Circular No. 129 / 2023

**Field Safety Corrective Action of Oxylog 3000 plus from Draeger Medical Systems Inc.**

## Important Safety Notice

Oxylog 3000 *plus* may not switch to mains supply following battery operation.

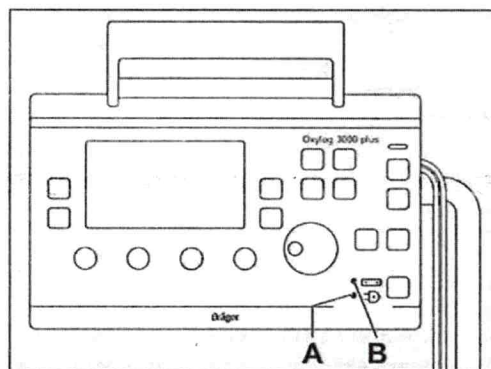
Prior to a device being used on a battery supply, ensure the correct switchover by disconnecting from and reconnecting the device to a mains supply. Please verify the colors of indicators A and B as per the diagram below:

A should display a green light, and B should display a green or yellow light. If B displays a red light, you should disconnect and reconnect or replace the battery.

Please make sure that the battery is always removed and reinserted or replaced after occurrence of the "No int. battery charging" alarm message, without removing the device from mains supply.

Your local Dräger Service representative or our service partner will contact you to arrange a date for a firmware update of the Printed Board Assembly Charger to be performed free of charge.
